**Addendum No. 3**  
**April 23, 2026**

Project: **SOUTHEAST TECHNICAL COLLEGE HOUSE CONSTRUCTION LAB**  
Sioux Falls, South Dakota  
Architecture Incorporated Project No. 3155

Scope of this Addendum:

**SITE DEMOLITION PLAN**  
SCALE: 1" = 20'-0"

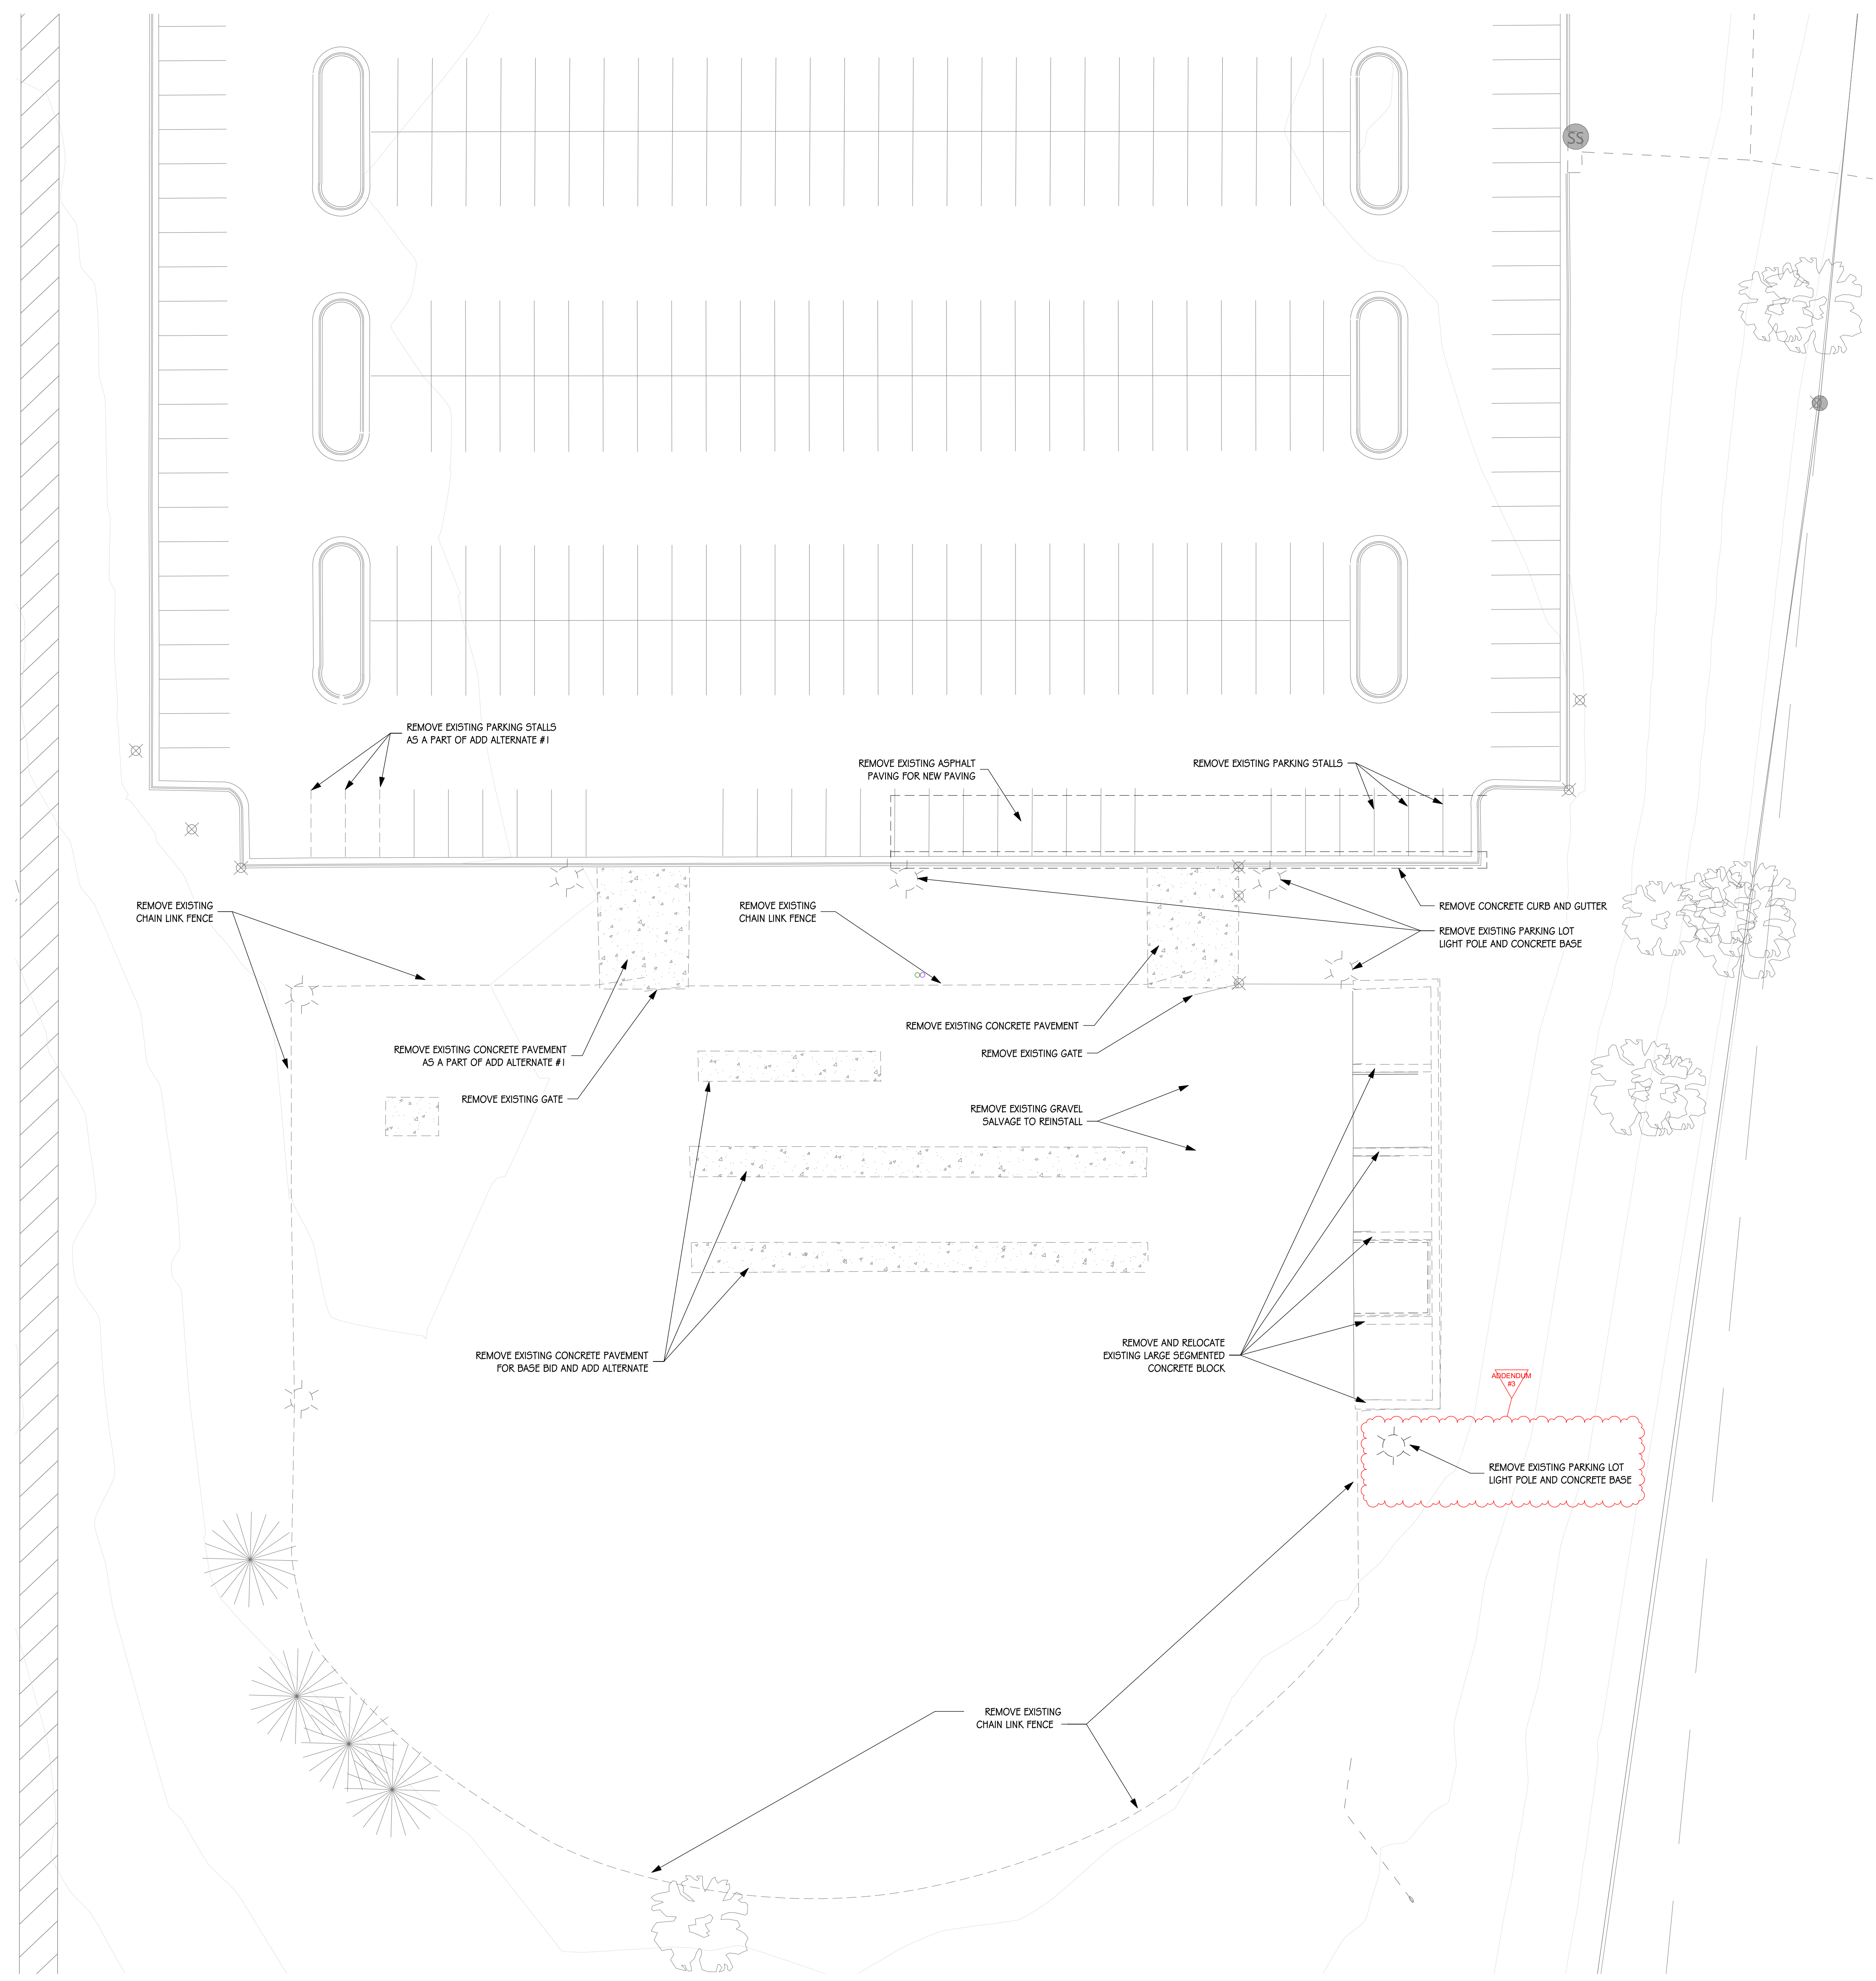
3) SHEET 2.21 – SITE DEMOLITION PLAN

- a) Remove existing parking lot light pole and concrete base south of existing large segmented concrete blocks, originally not shown in the site demotion plan; see *revised* Sheet 2.21 *revision* dated 4-22-2026 attached to the end of this addendum for the location of additional light pole to be removed.

**1 PLAN DETAIL - BASE BID**  
4.40 SCALE: 1/2" = 1'-0"

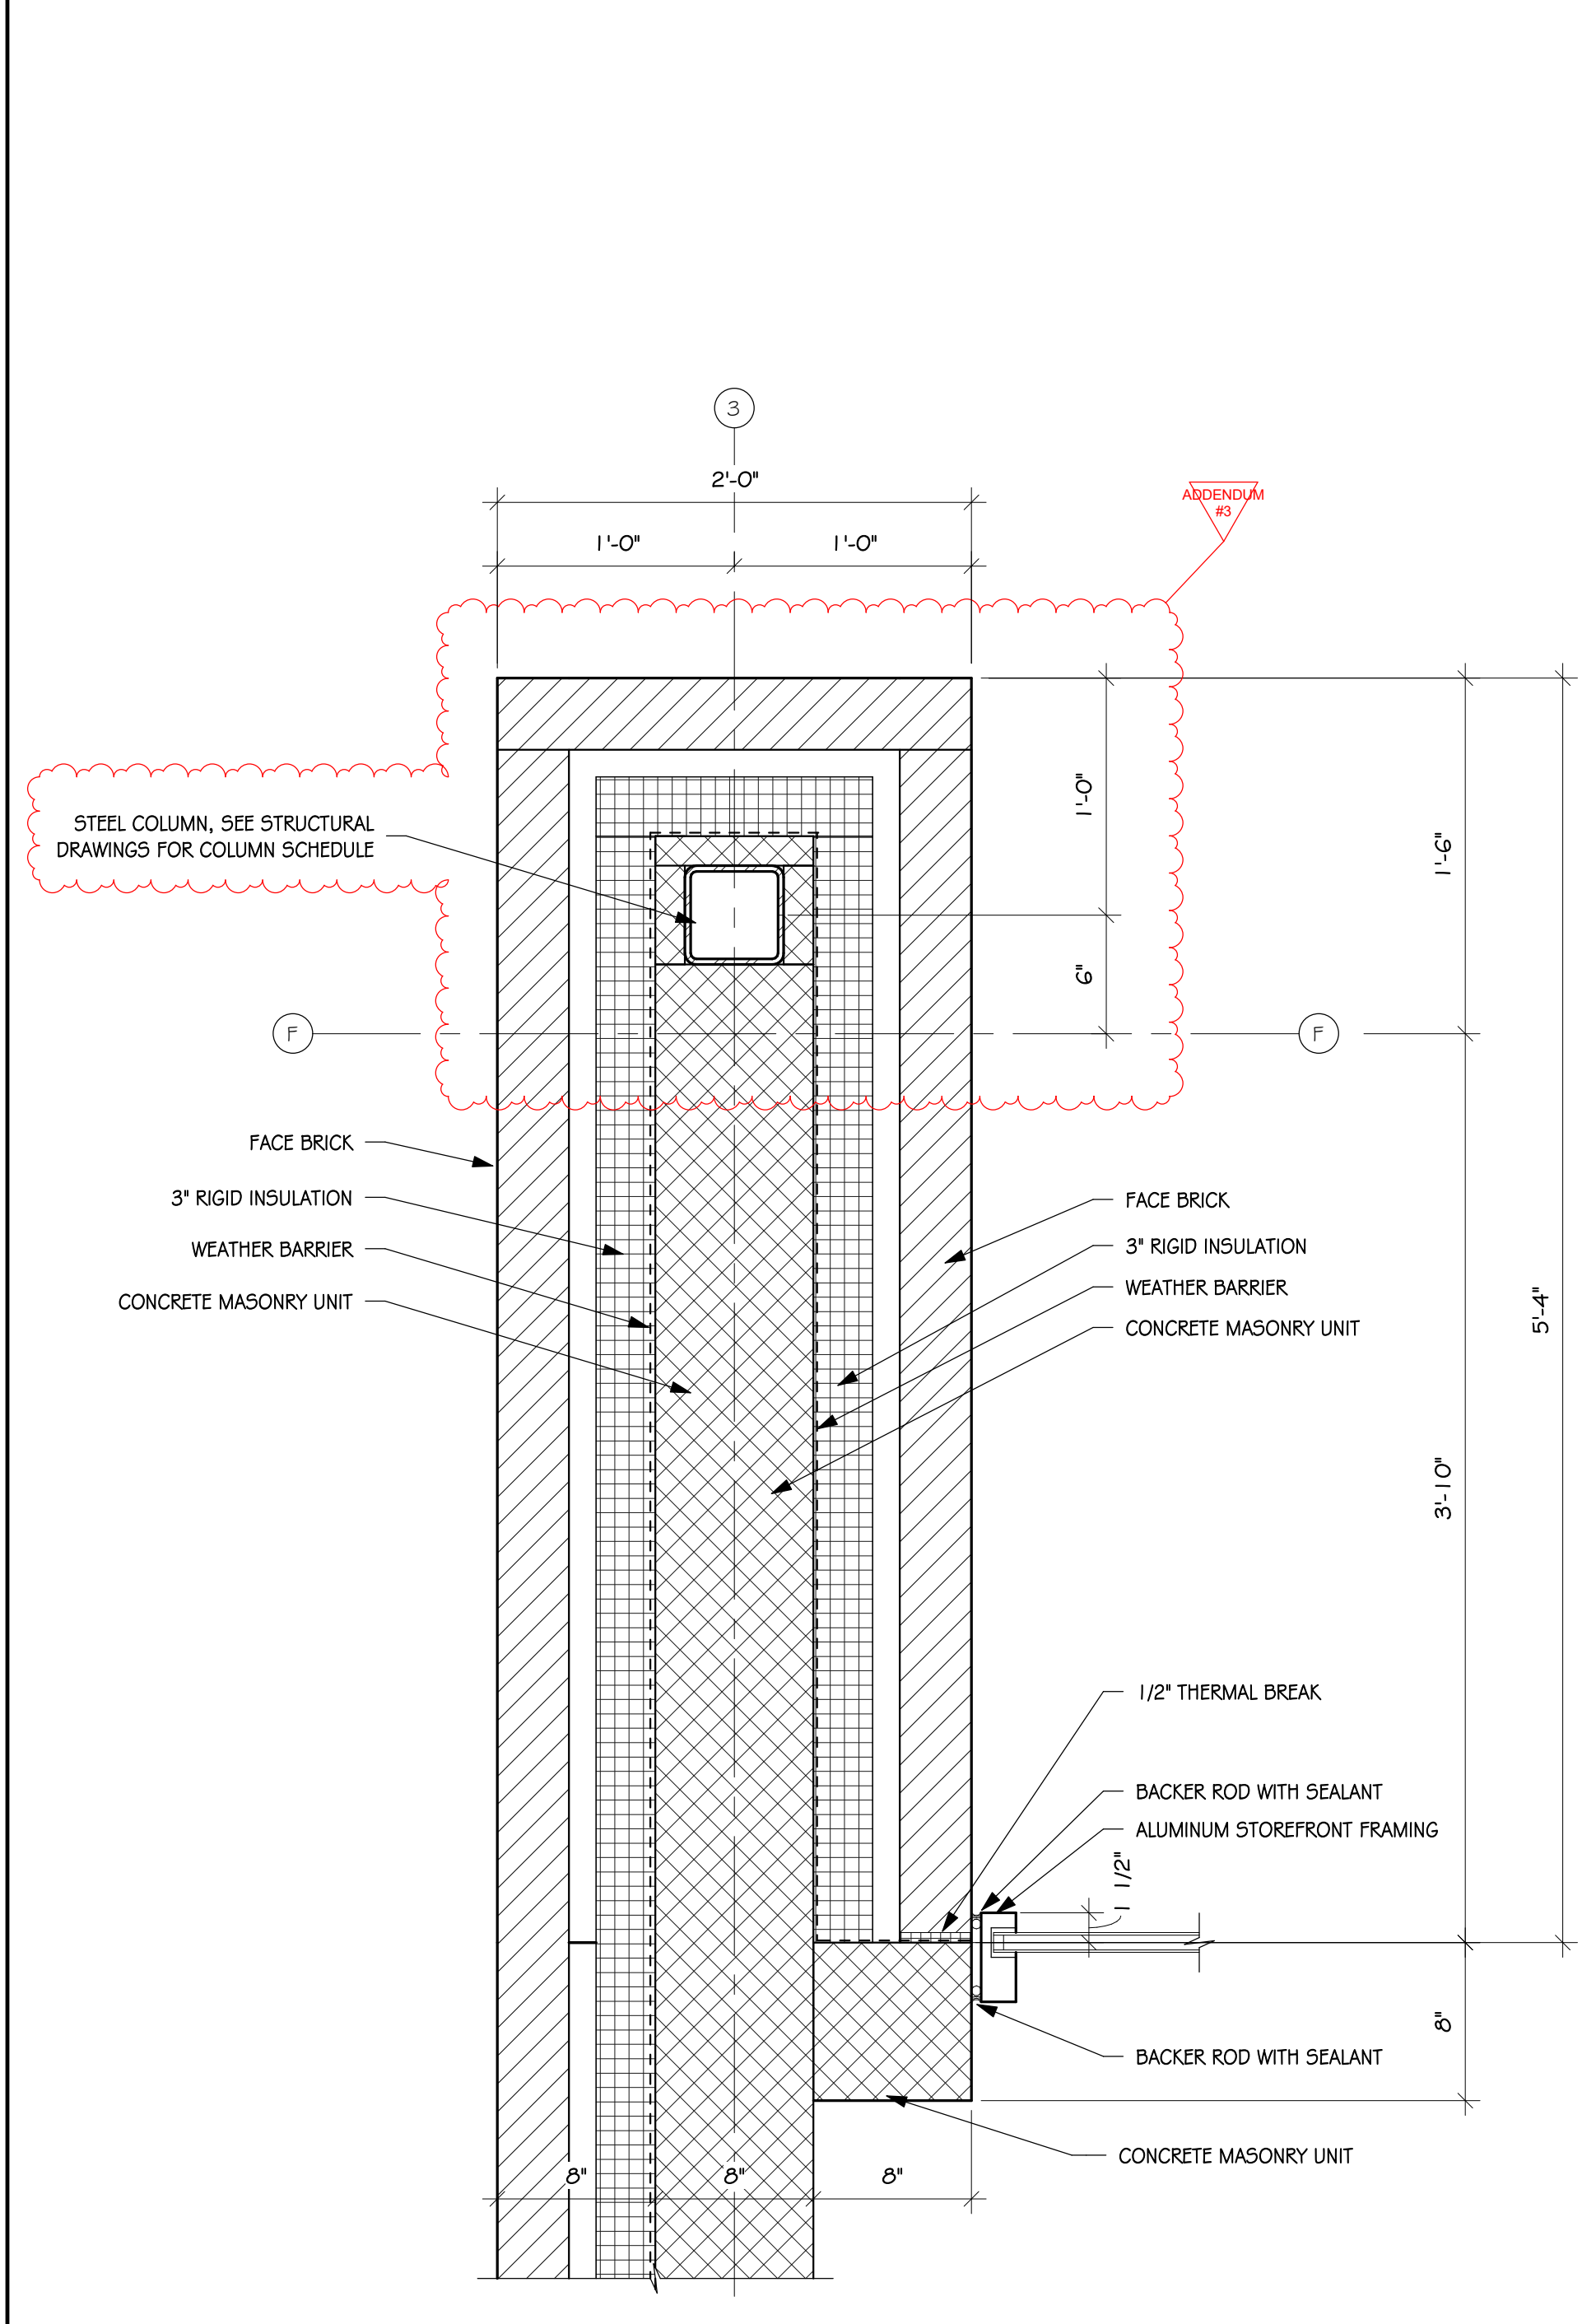
4) SHEET 4.40 – PLAN DETAILS

- a) CLARIFICATION: Architectural Detail 1/4.40 has been modified to show steel column north of Grid F as shown in structural detail 6/3.33; see *revised* Sheet 4.40, *revision* dated 4-23-2026 attached to the end of this addendum.

3 DETAIL - ADD ALTERNATE  
5.43 SCALE: 1/2" = 1'-0"

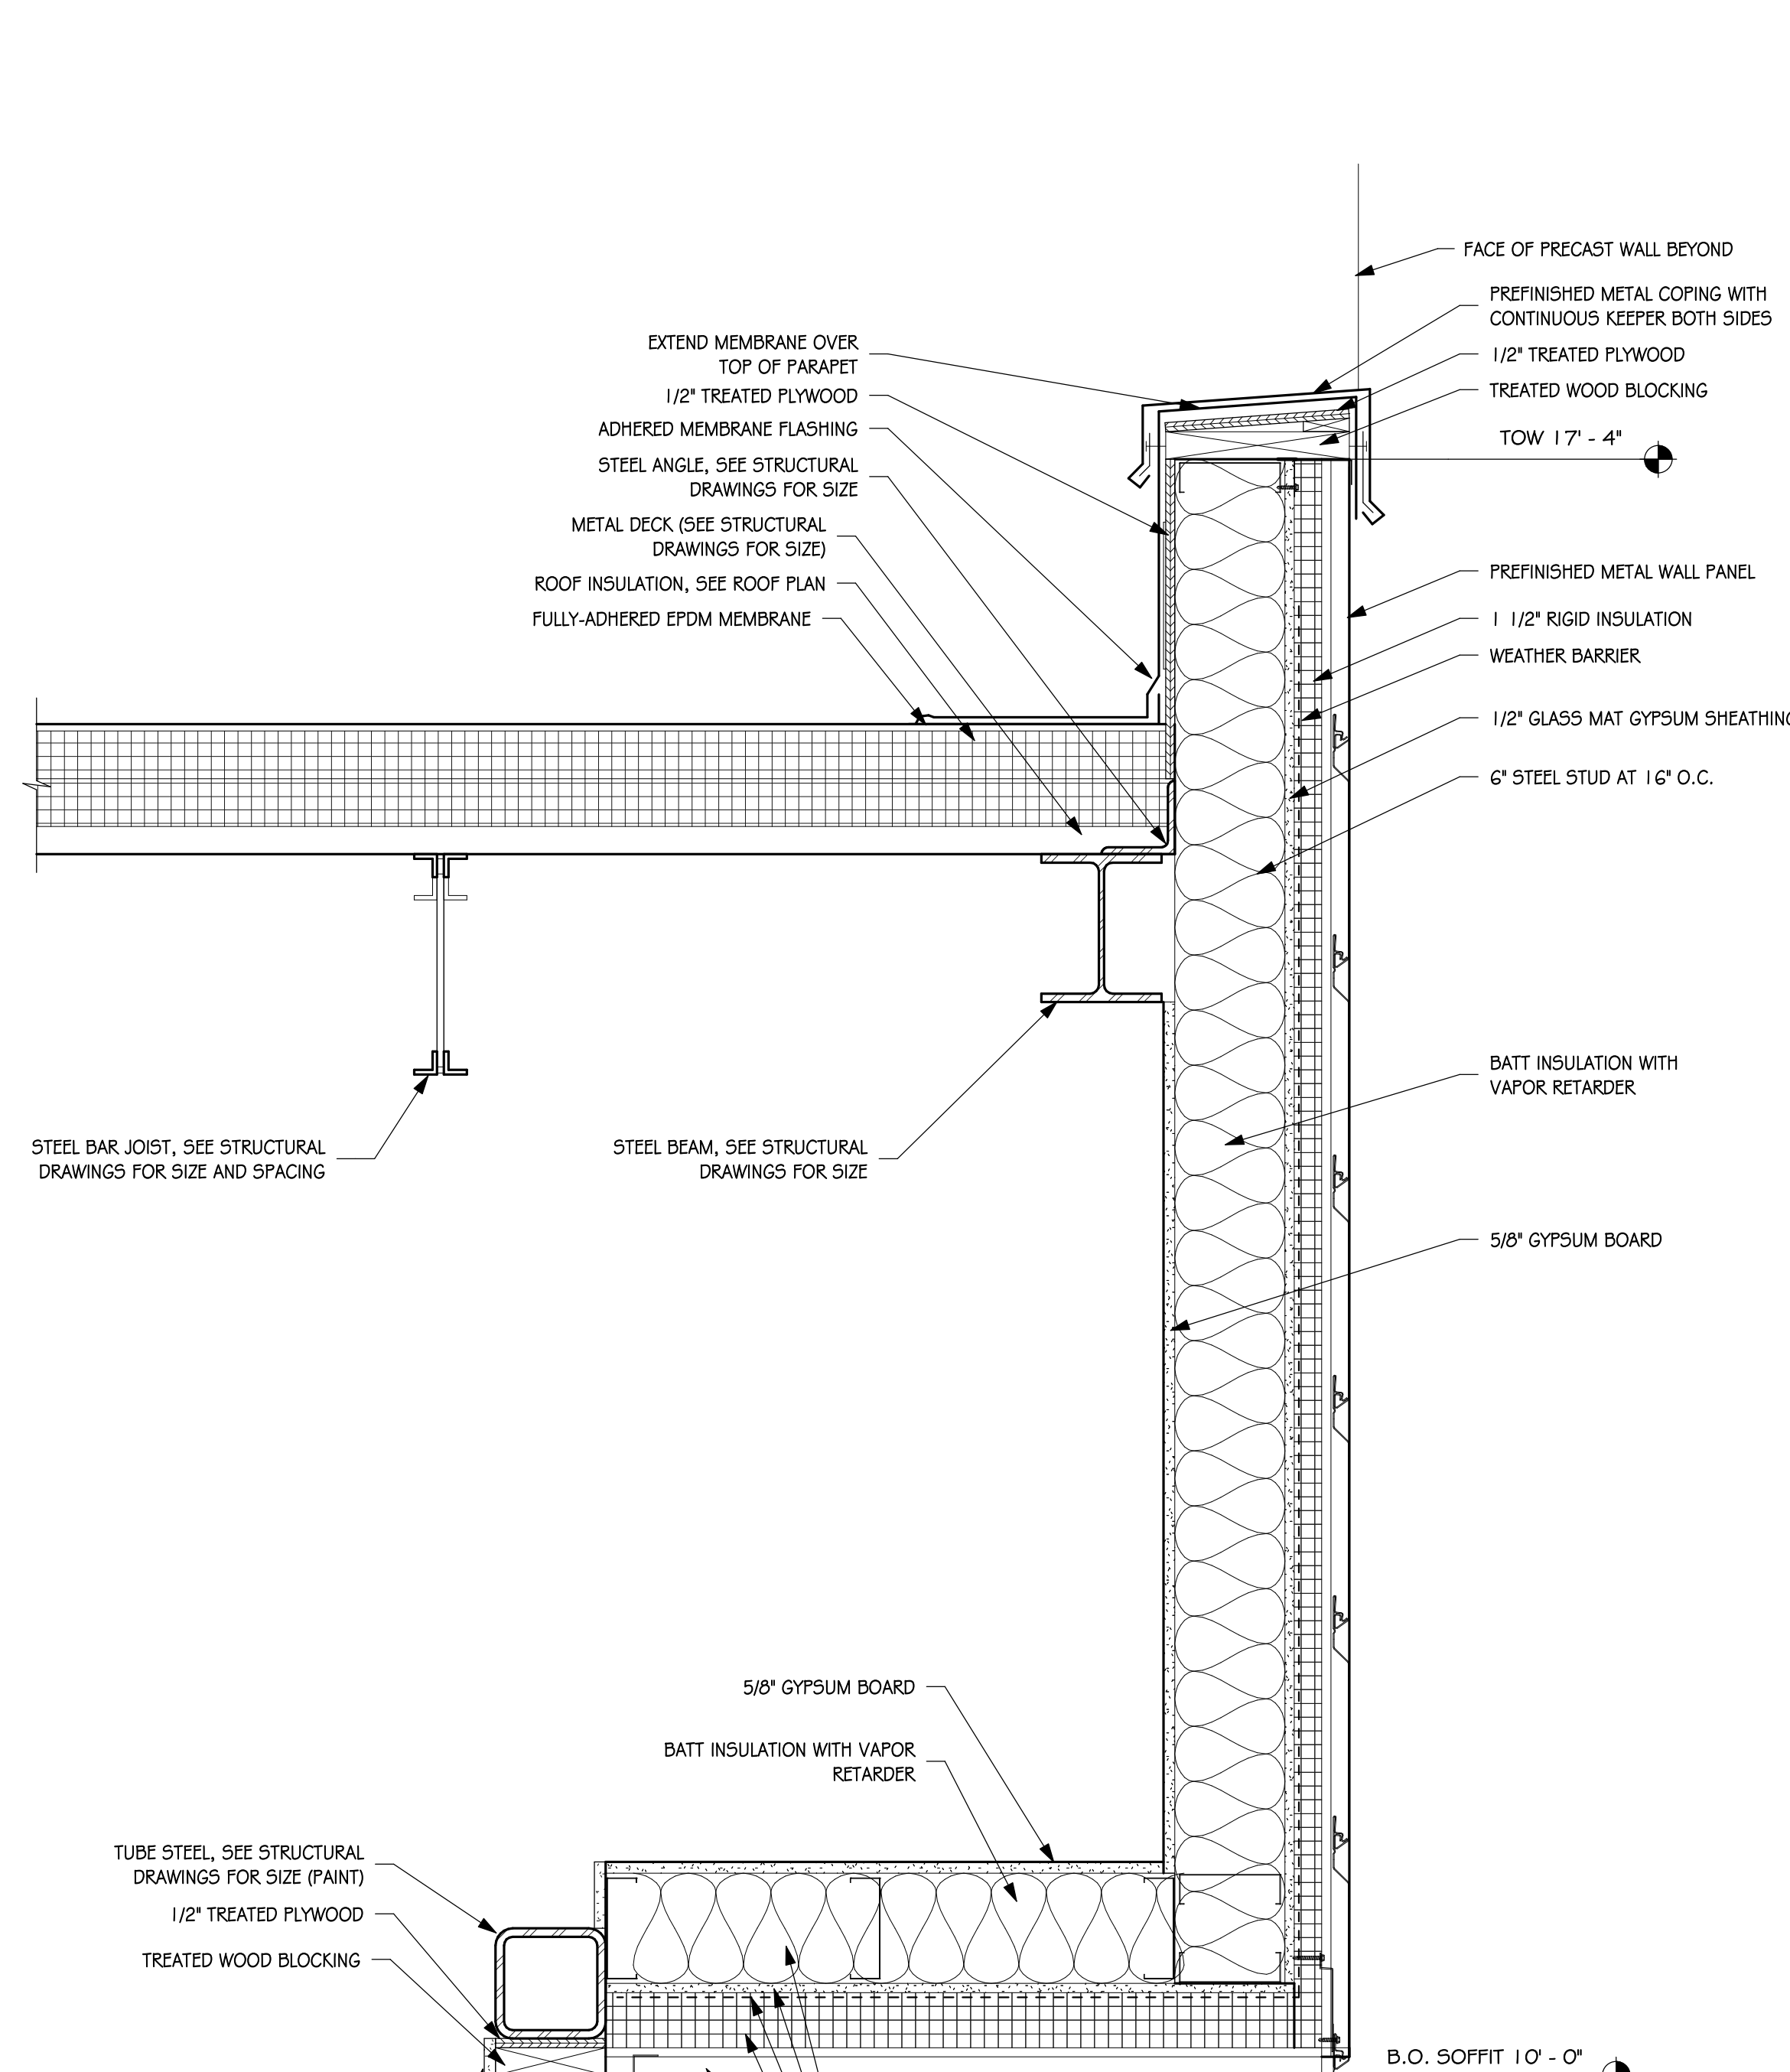
5) SHEET 5.43 – SECTION DETAILS

- a) CLARIFICATION: Detail 3/5.43 has been modified to show treated wood blocking and steel angle above the aluminum storefront framing as shown per *revised* Sheet 5.43, *revision* dated 4-23-2026 attached to the end of this addendum.
